**From:** Mccray, Sean-Ryan CTR (USA) [sean-ryan.mccray.ctr@navy.mil]  
**Sent:** Wednesday, May 5, 2021 11:14 AM  
**To:** Liscio, Matthew P CIV USN NAVSEA DET RASO VA (USA) [matthew.liscio@navy.mil]  
**CC:** Stoick, Paul T CIV USN NAVFAC SW SAN CA (USA) [paul.stoick@navy.mil]  
**Subject:** FW: Hunters Point Bldg 211/253 - Trench Survey Unit Package #2  
**Attachments:** Bldg 211-253 Trench Survey Unit #2.pdf; Trench area 12212020.xlsx

**From:** Womack, Brett <BWomack@GilbaneCo.com>  
**Sent:** Wednesday, May 5, 2021 11:06 AM  
**To:** Mccray, Sean-Ryan CTR (USA) <sean-ryan.mccray.ctr@navy.mil>  
**Subject:** [Non-DoD Source] RE: Hunters Point Bldg 211/253 - Trench Survey Unit Package #2

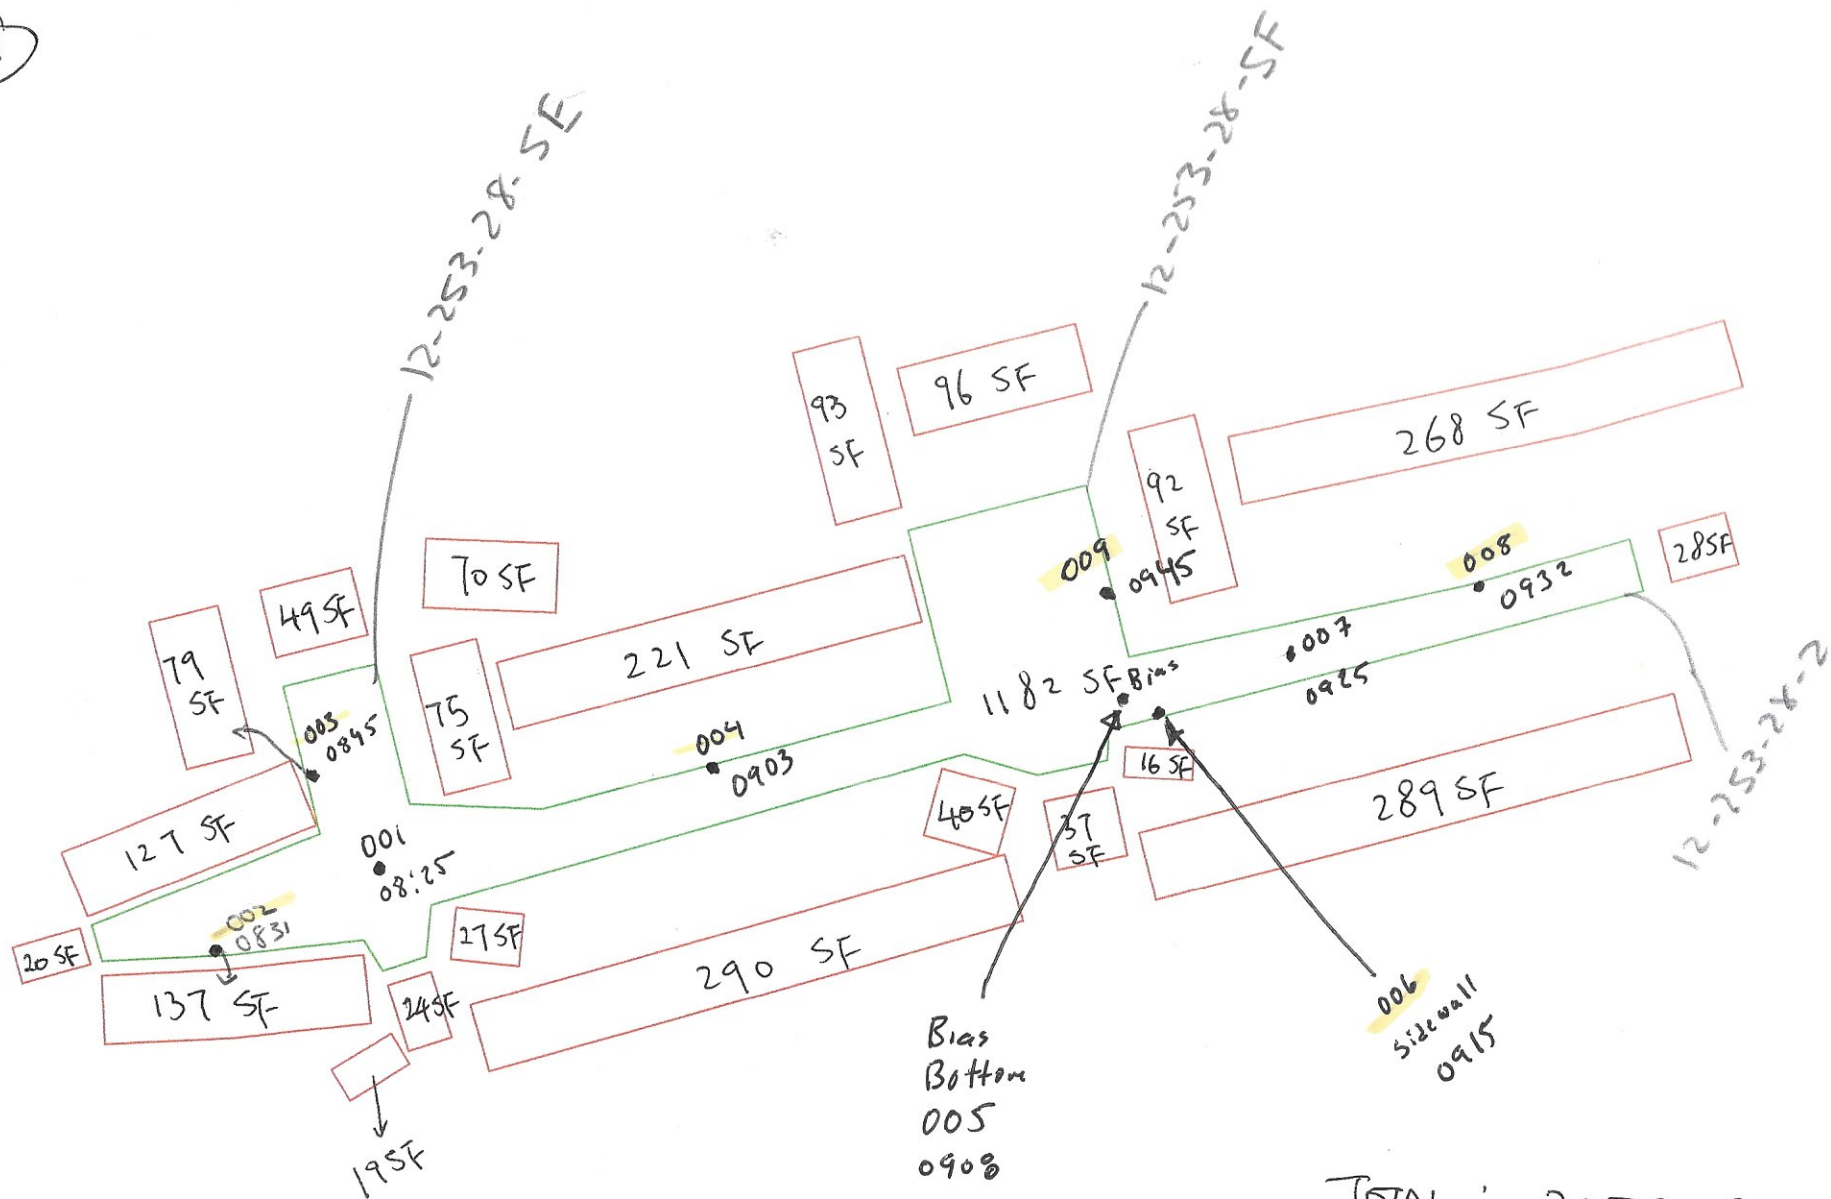
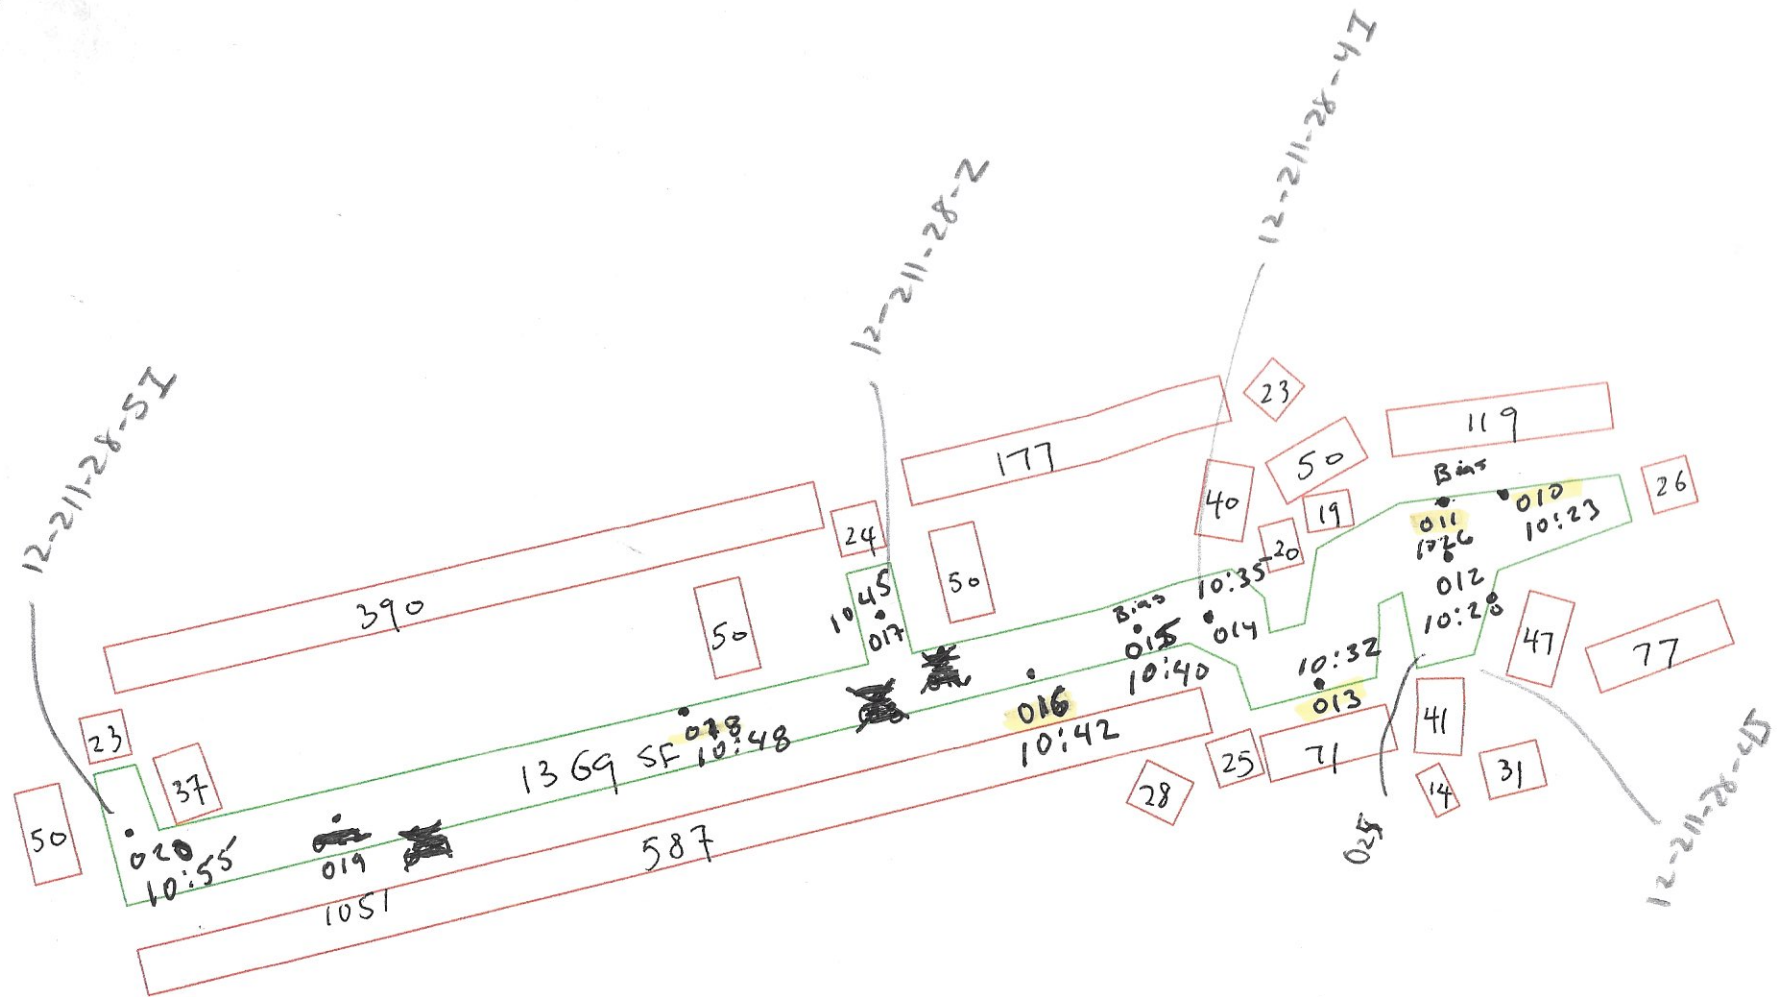
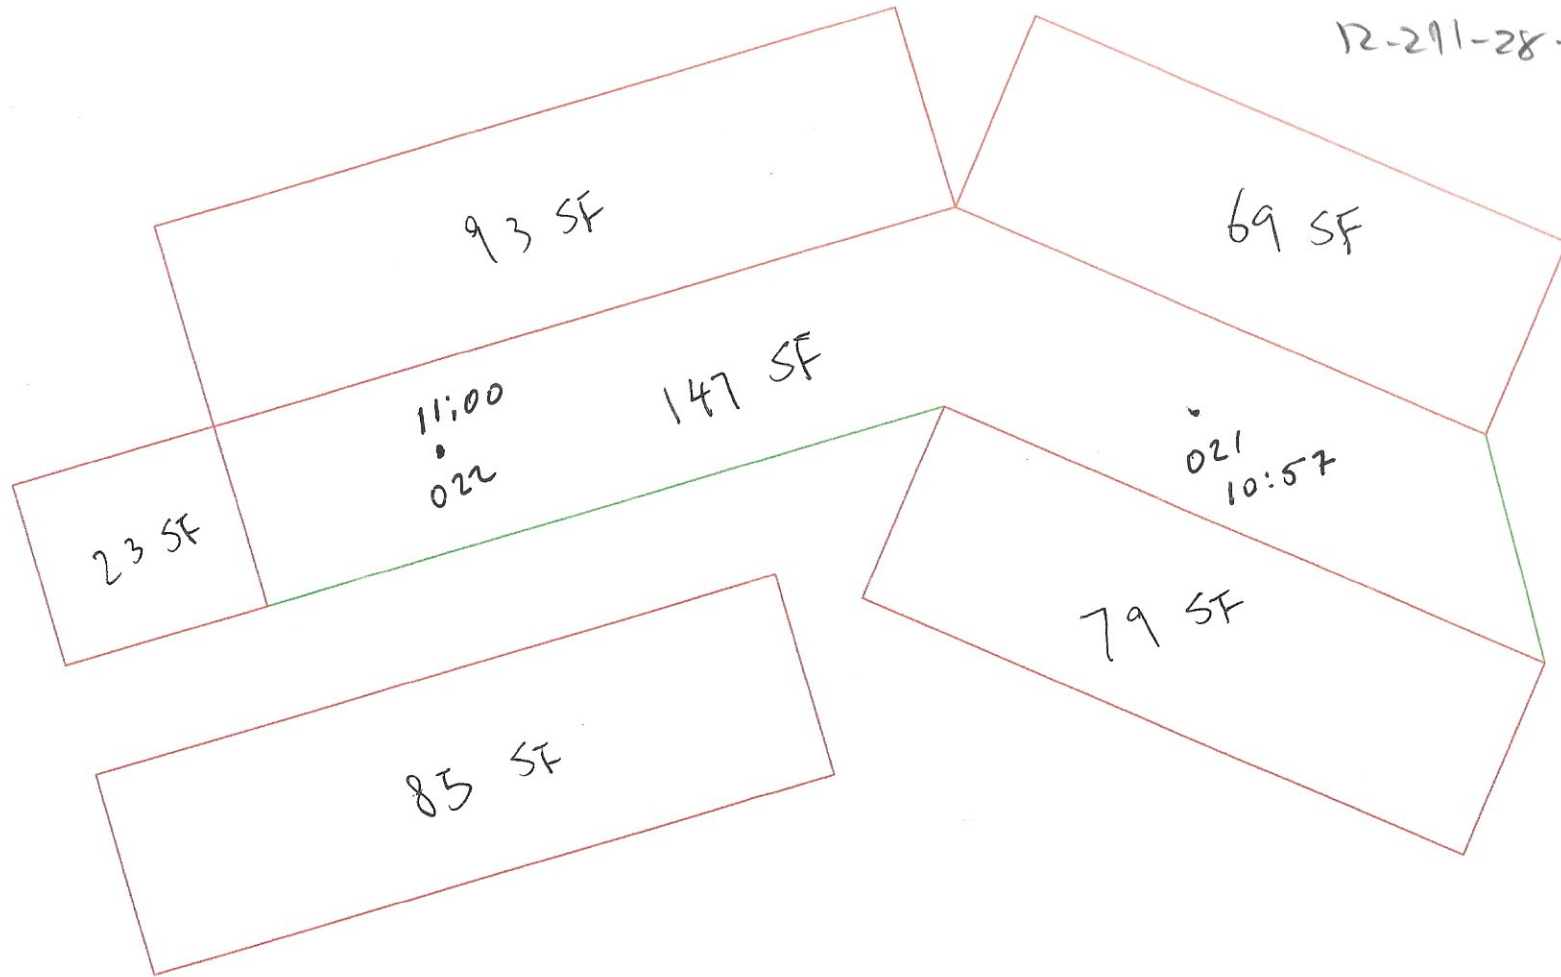
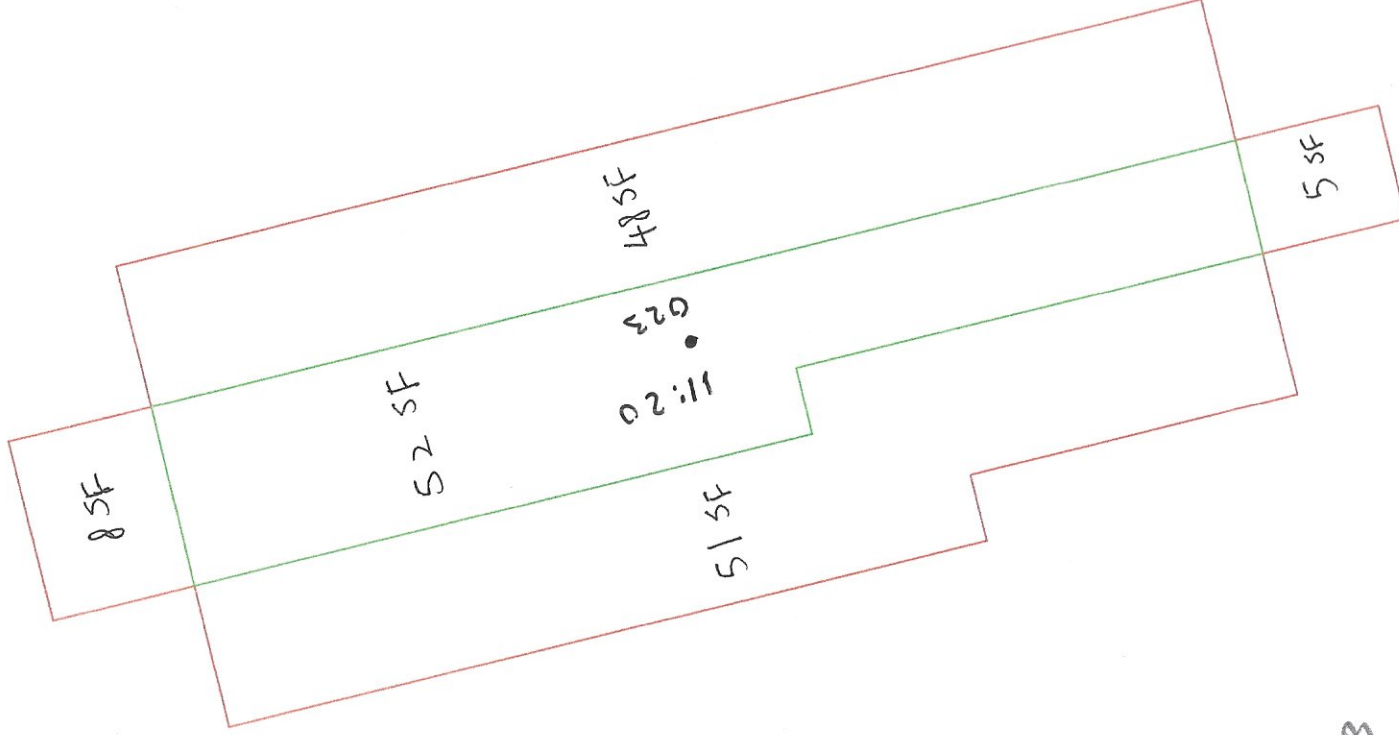
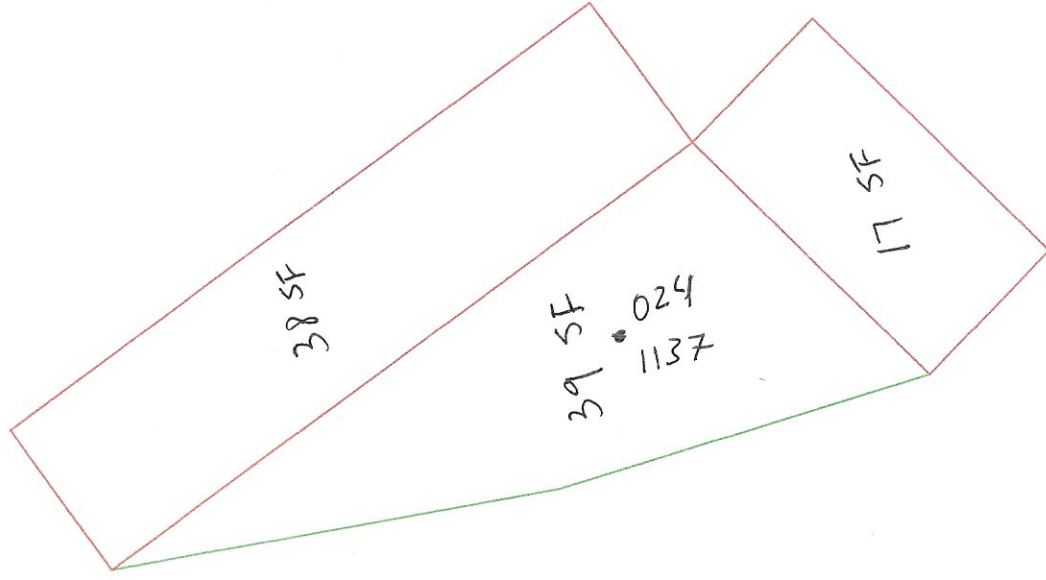
1. If you look at page 4 (maps) and scroll through you can see individual trenches with sample locations. But they look like dots randomly placed in there, so you can’t see the systematic nature of it. I can’t think of a way to “show” the systematic nature off the top of my head, but Gilbane had to have some method of determining the systematic locations – can we show this in the maps? Essentially, I understand that Gilbane is saying you did it systematically, and the work plan shows that, but is there a way to show us that you did on the map? I.e. the map could be more representative in my opinion.

It's hard to tell from the maps what the rationale was for the sampling locations. The work plan has them being systematic based off of a random start location but with the maps being broken apart it's hard to tell if they were or not. Is there a way to show this?

1. The number of samples for each trench are determined per total area as the figures and table are shown
2. The trench is divided systematically/equally into segments in the field. For example, trench #1 is allocated with 8 samples, then the trench is divided into 8 segments.
3. Sample location (wall or floor) is randomly selected within that segment.

1. The number of samples for each trench are determined per total area as the figures and table are shown
2. The trench is divided systematically/equally into segments in the field. For example, trench #1 is allocated with 8 samples, then the trench is divided into 8 segments.
3. Sample location (wall or floor) is randomly selected within that segment.

For the systematic samples, the total volume of square meters of trenches in the survey unit was calculated. Based on the total square meters, the number of samples representative for each individual trench was derived. Once the number of random/systematic samples per trench was determined, a random starting location was selected and then the balance of the samples (if more than one) within that trench were systematically spaced relative to the random starting point. For biased samples and removal actions, the highest radiological survey readings per trench were pinpointed, and based on that data samples were collected and remediations performed where applicable.
